WOLLONGONG CITY COUNCIL

# Traffic Committee Minutes of Meeting

14 November 2023

Item 2.7 – NORTH WOLLONGONG, Squires Way and George Hanley Drive – Bus Zone Relocation, page 1 of 2

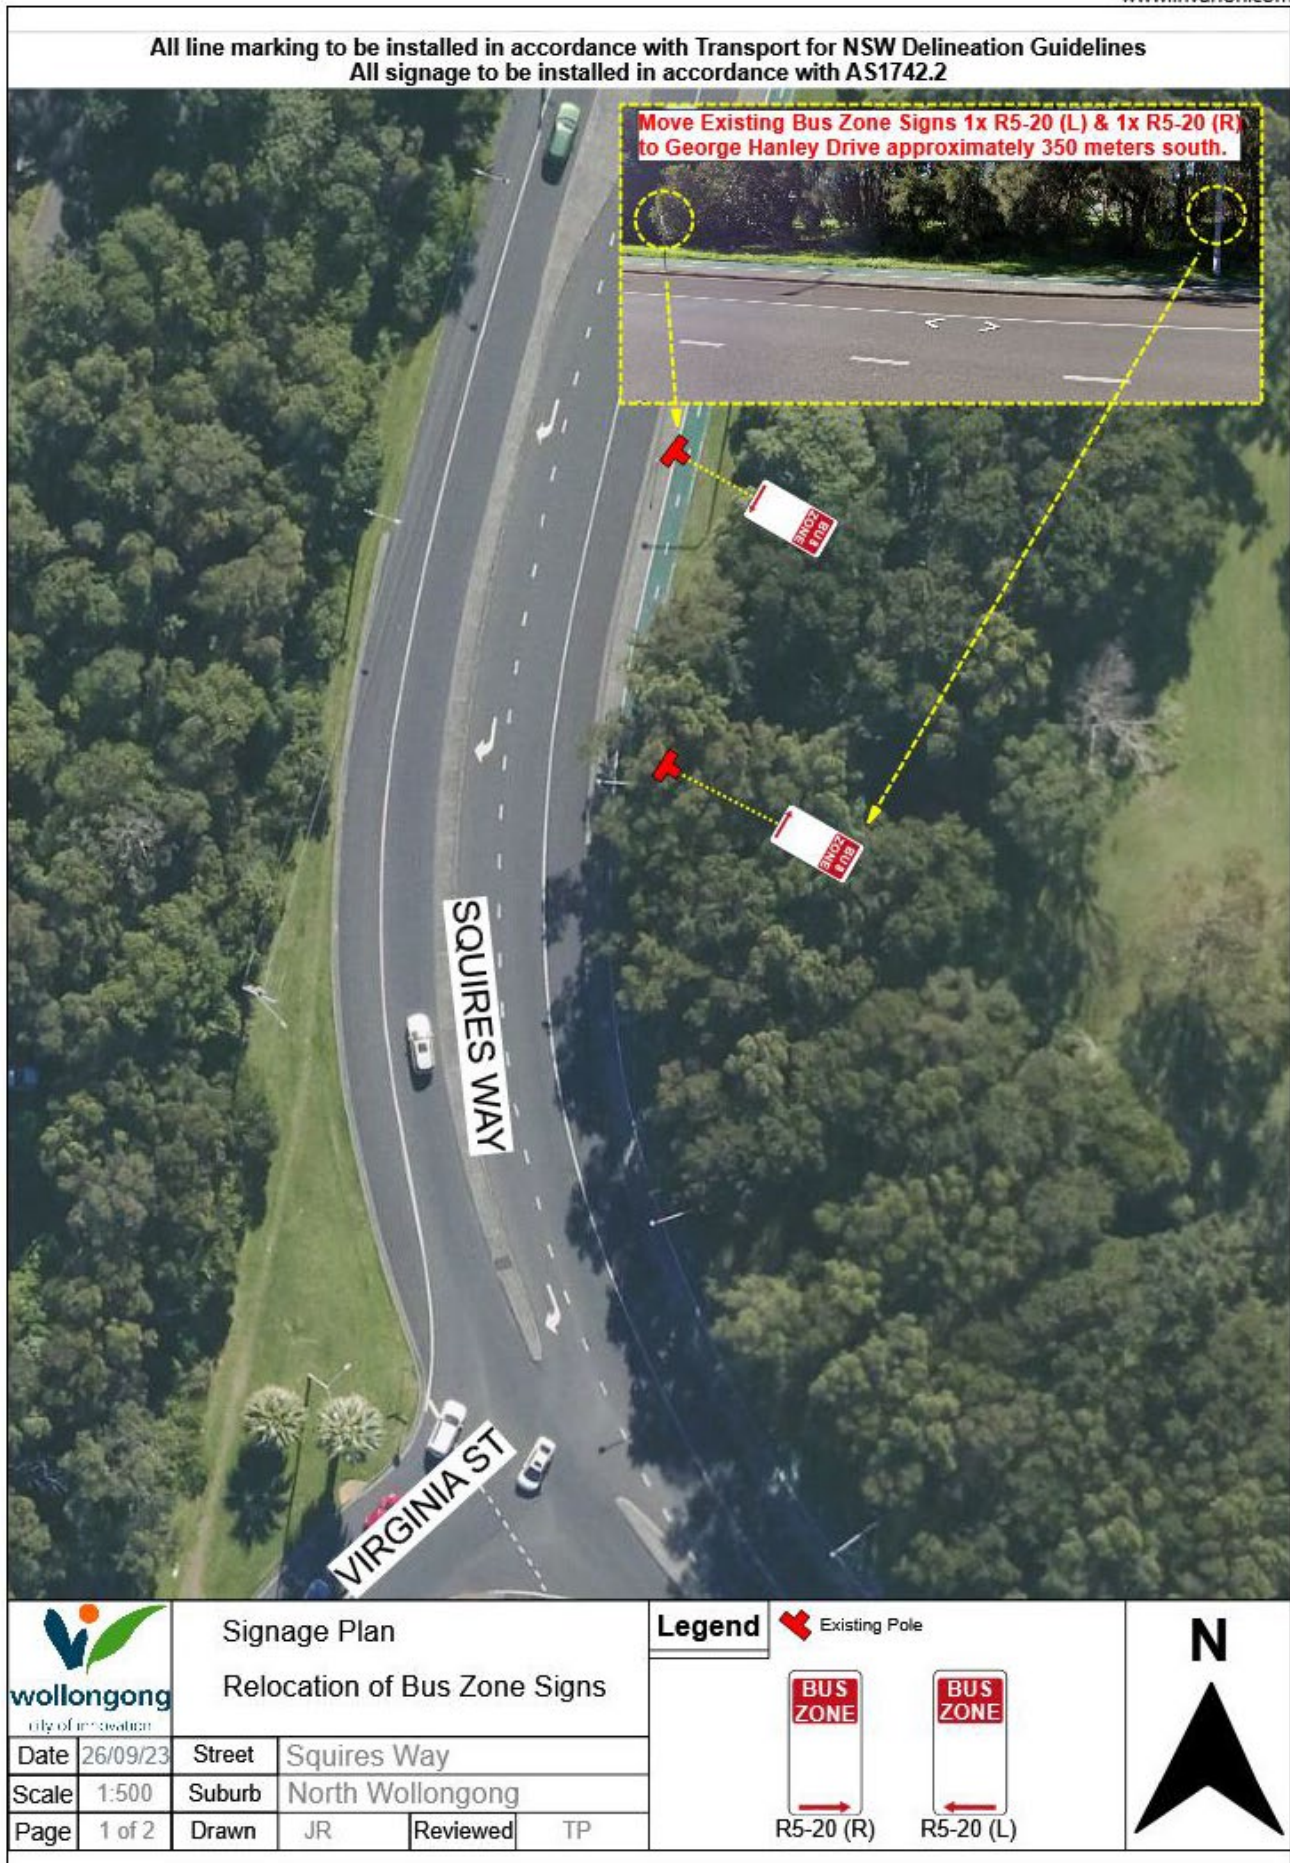
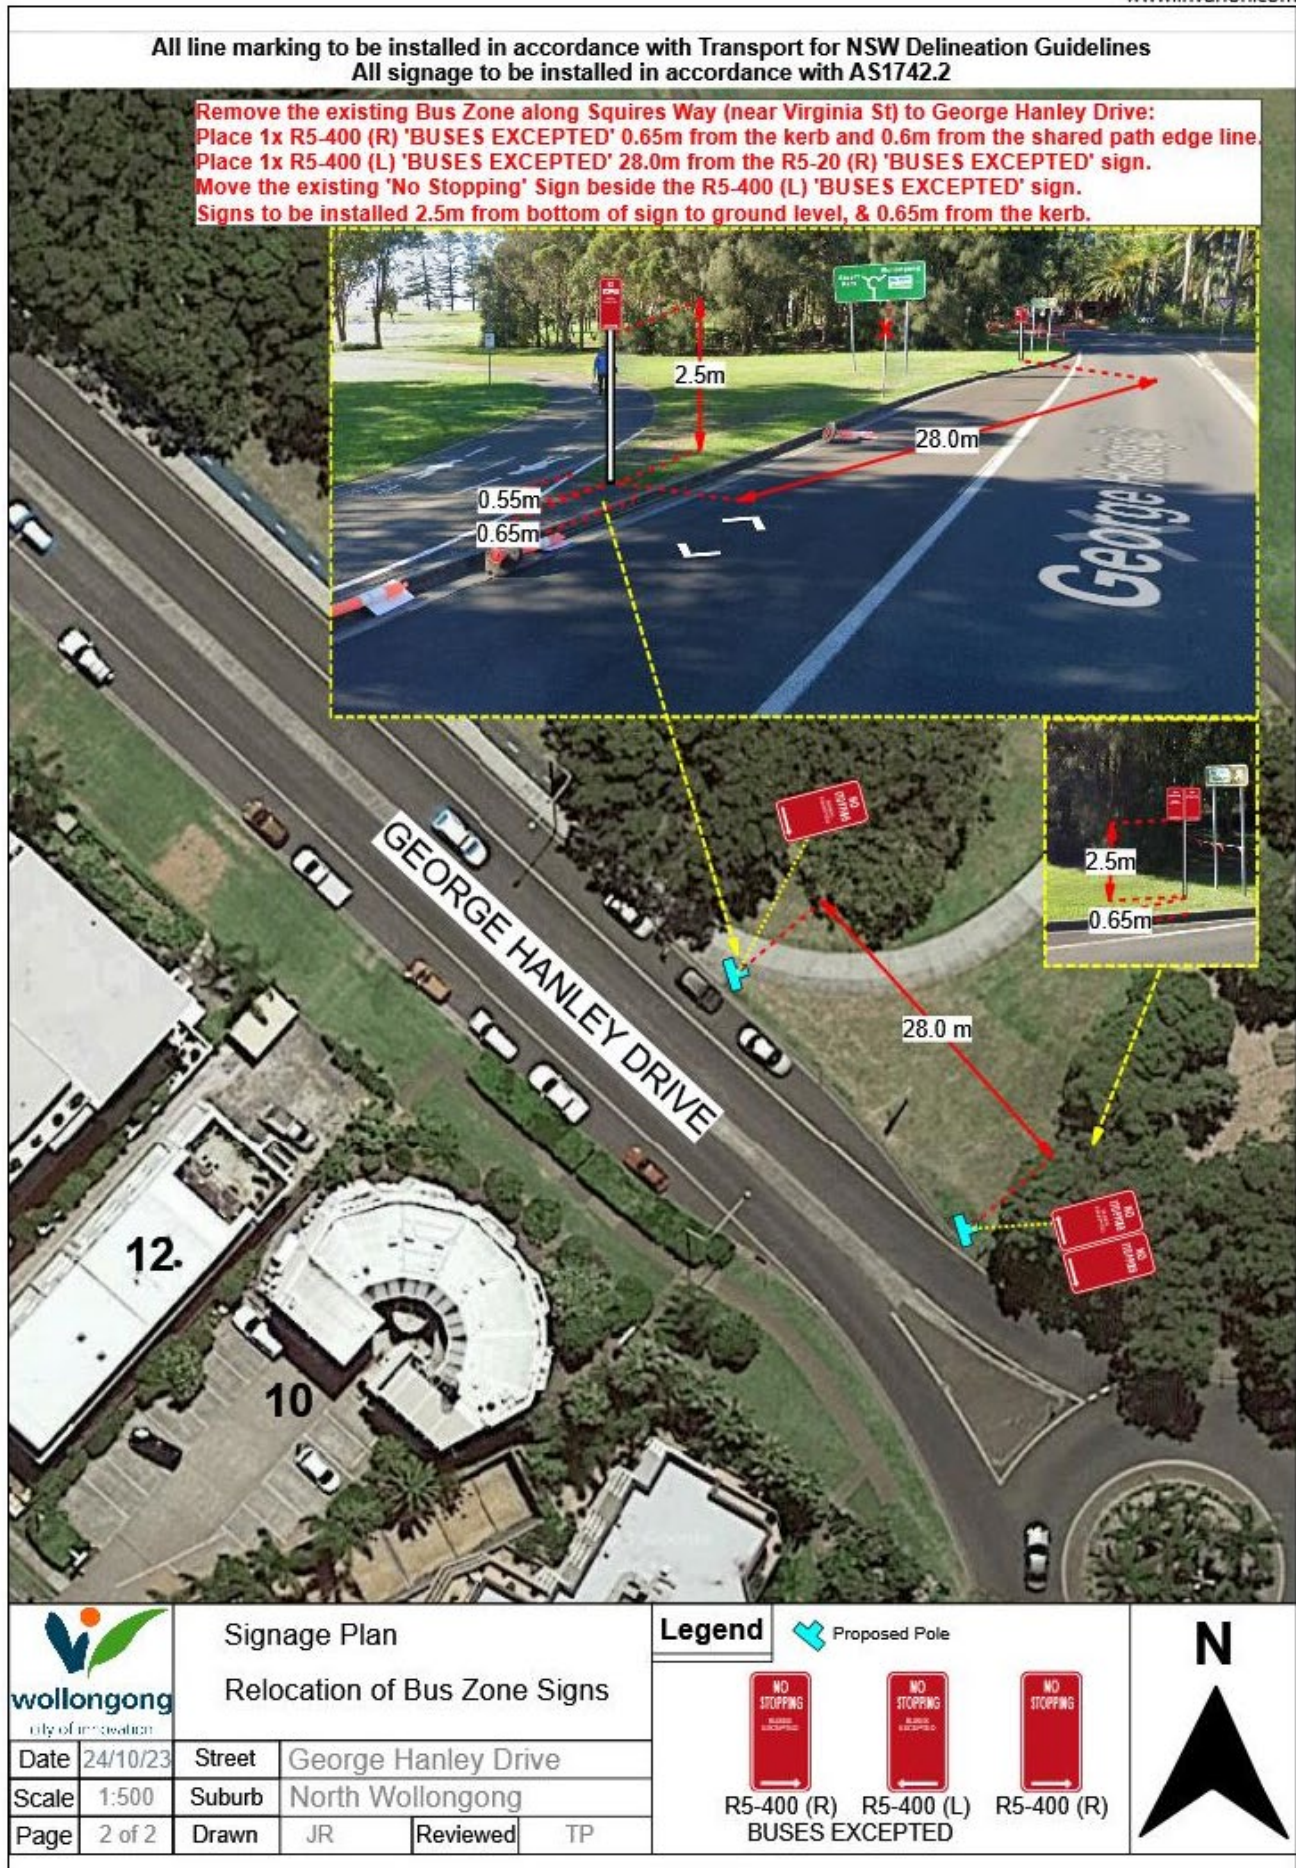
Council has reviewed the bus zone at Squires Way near Virginia Street. Currently, the existing bus zone at the south bound side is not currently being used by Premier Illawarra or Dions public bus service.

It is proposed to move the existing bus stop/zone closer to the foreshore along George Hanley Drive, North Wollongong, before reaching the roundabout with Kembla Street. The 'Bus Zone' signs are to be replaced to 'No Stopping Buses Excepted' noting the bus stop is not active but may be in the future.

The attached plan be approved.

Item 2.8 – NORTH WOLLONGONG, Cliff Road – Stuart Park Speed Zone Review, page 1 of 5

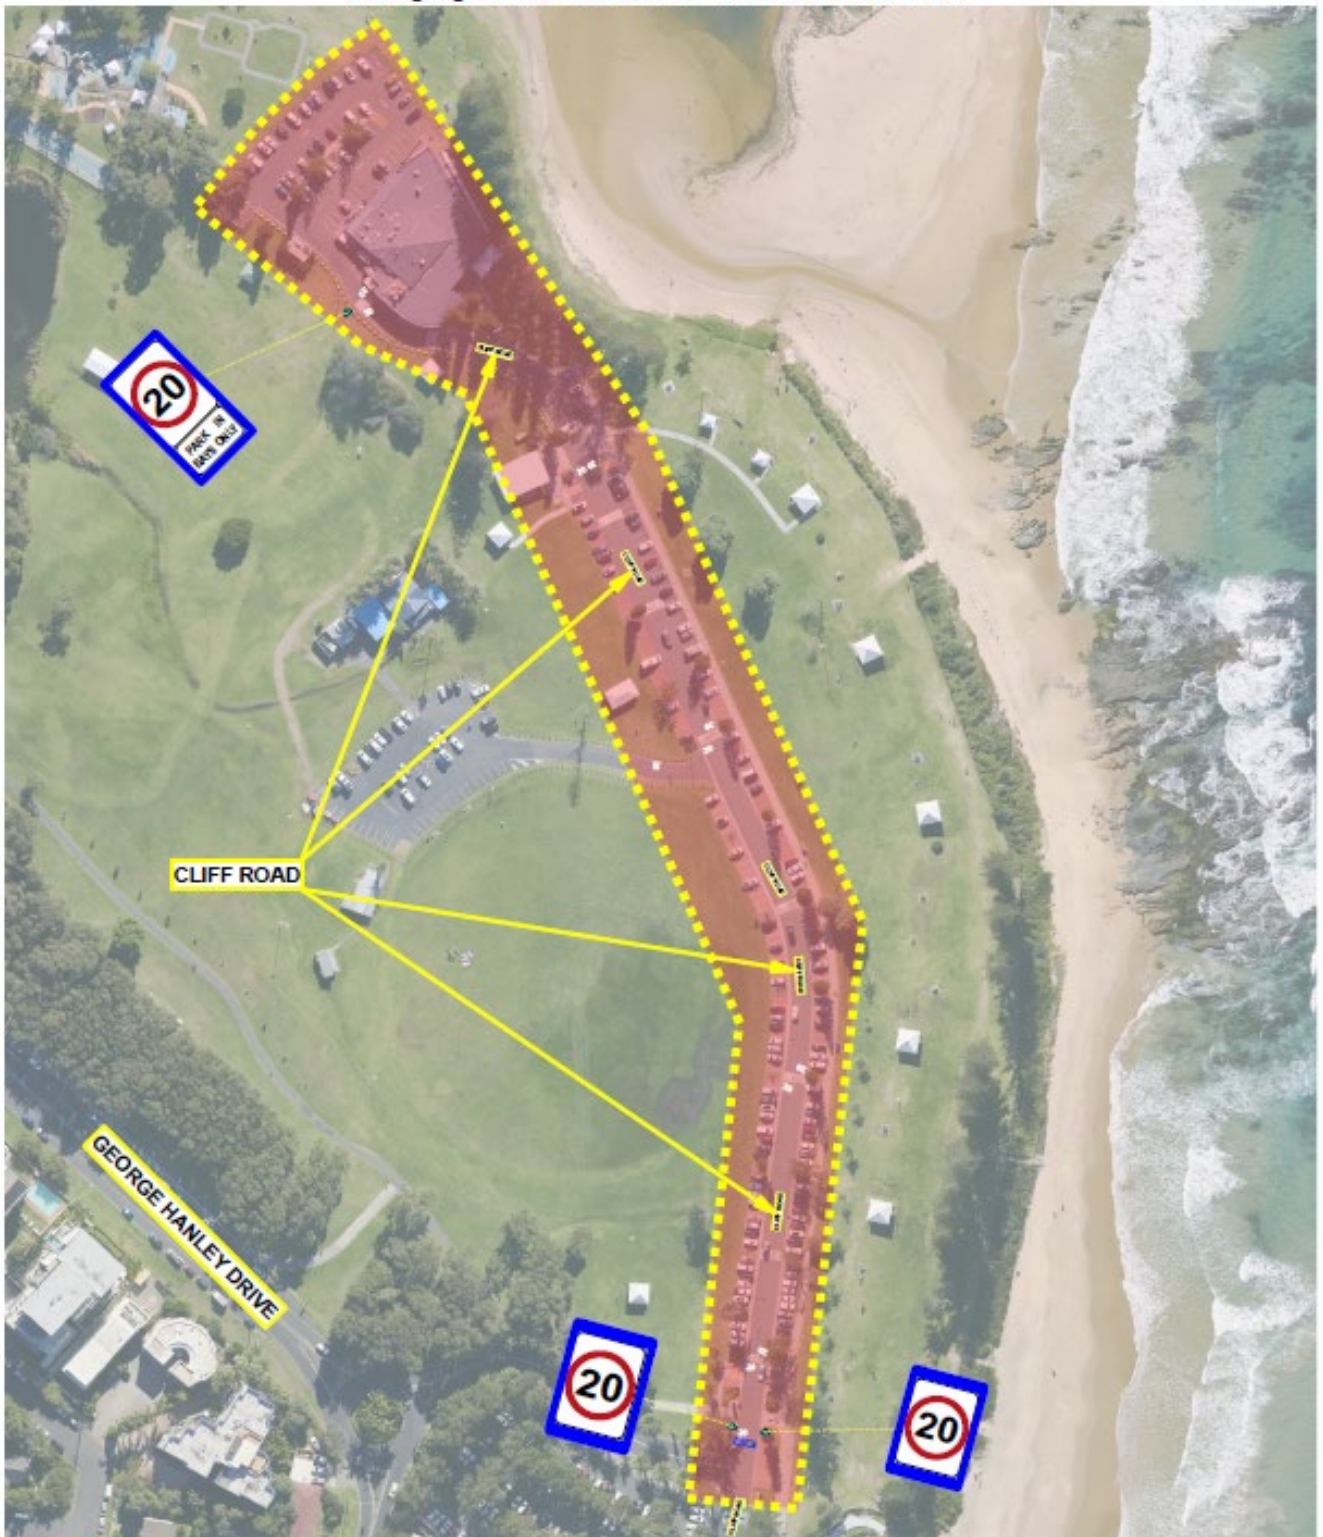
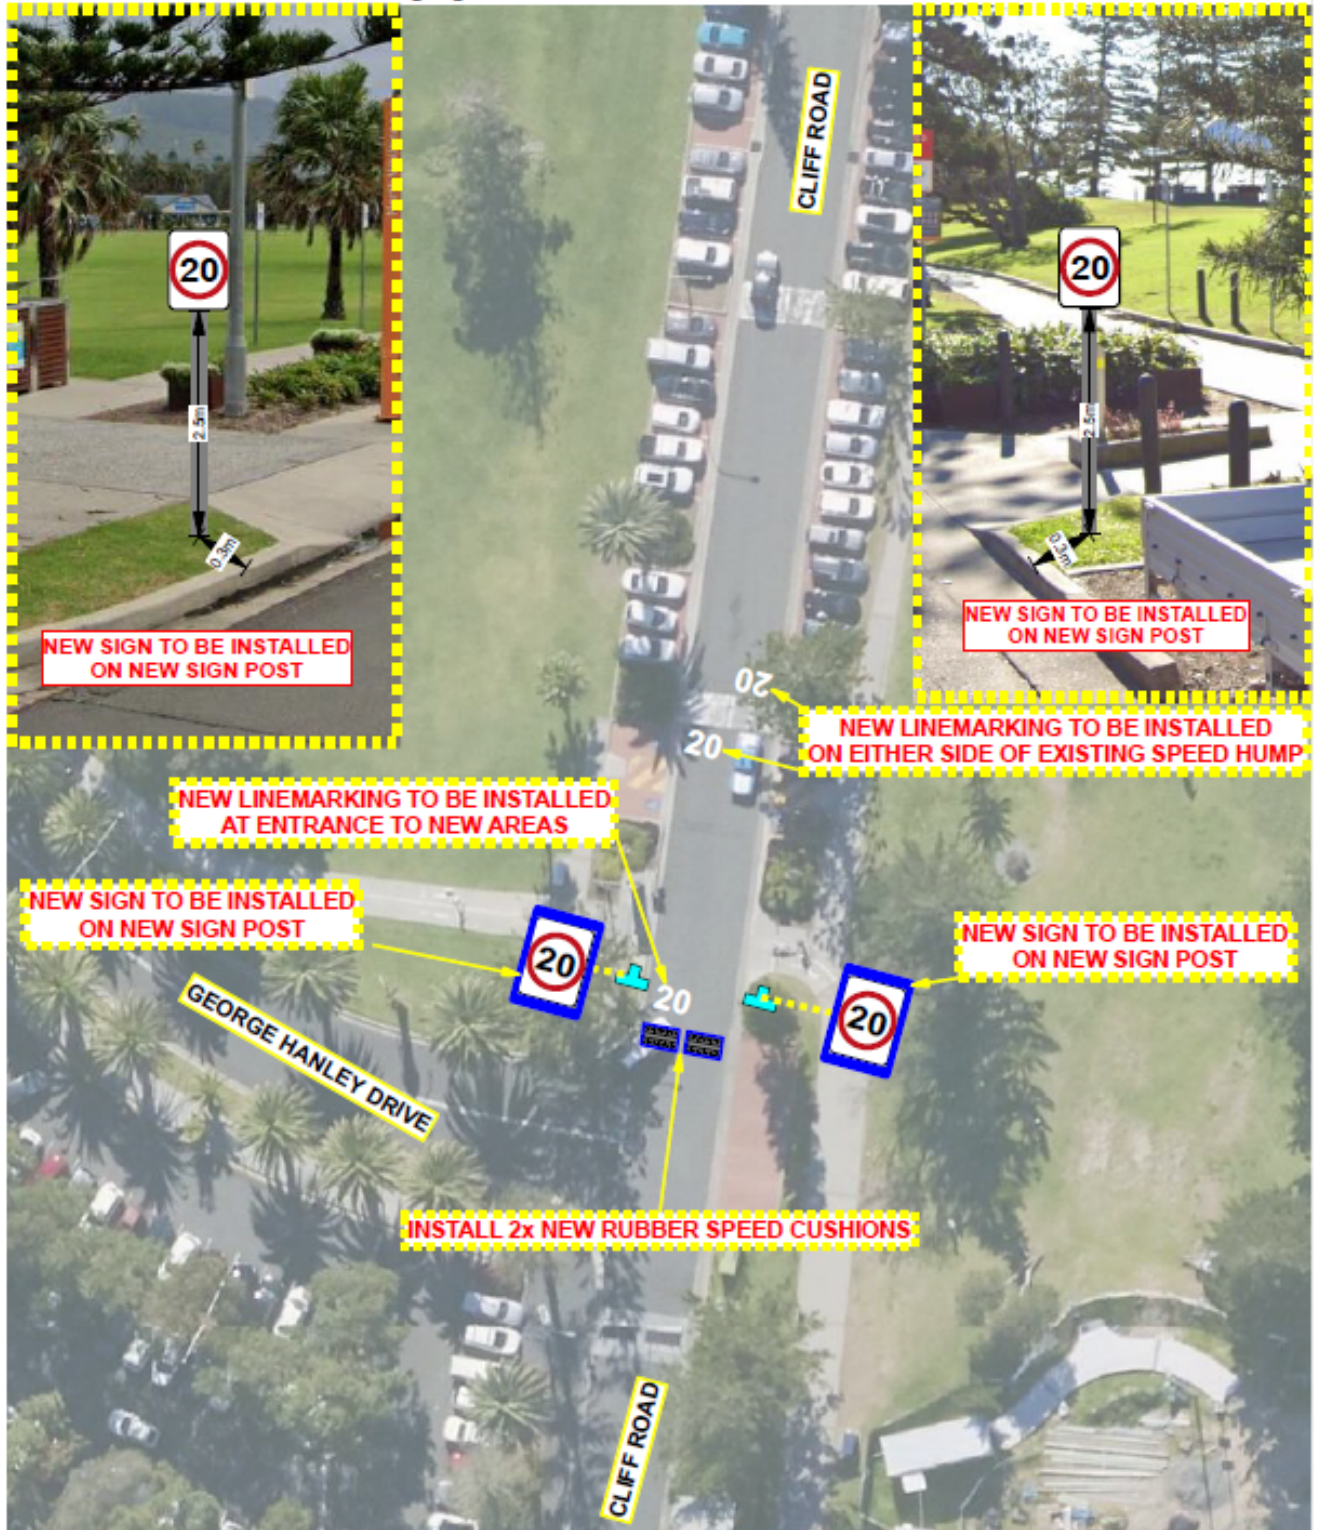
The Masterplan recommends a speed zone reduction from the existing 40km/h High Pedestrian Activity Area to a 10km/h. However, based on the updated [Speed Zone Guidelines](#) prepared by Transport for NSW (TfNSW), a 20km/h speed environment in the context of the car park and surrounding recreational space would be more suitable.

The attached plan be approved subject to TfNSW speed zone review.
